**2006 IRC
Recommended Action for IRC Section R602.10.5
Continuous Structural Panel Sheathing (Wall Bracing)**

The State of Minnesota who has Adopted the 2006 IRC

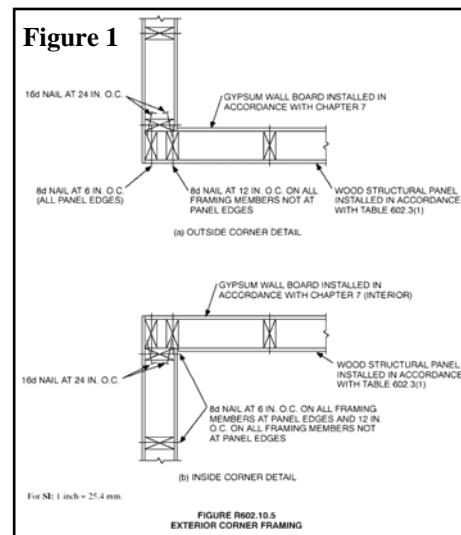
A more appropriate solution to the above concern would have been to clarify that the corner detail in Figure R602.10.5 (see Figure 1 above) requires a minimum 2-foot corner return panel at the ends of a continuously sheathed braced wall line. This would appropriately allow a transition to other bracing methods on other wall lines while also properly adhering to the research data that supports the continuous sheathed bracing method first introduced in the 2000 IRC.
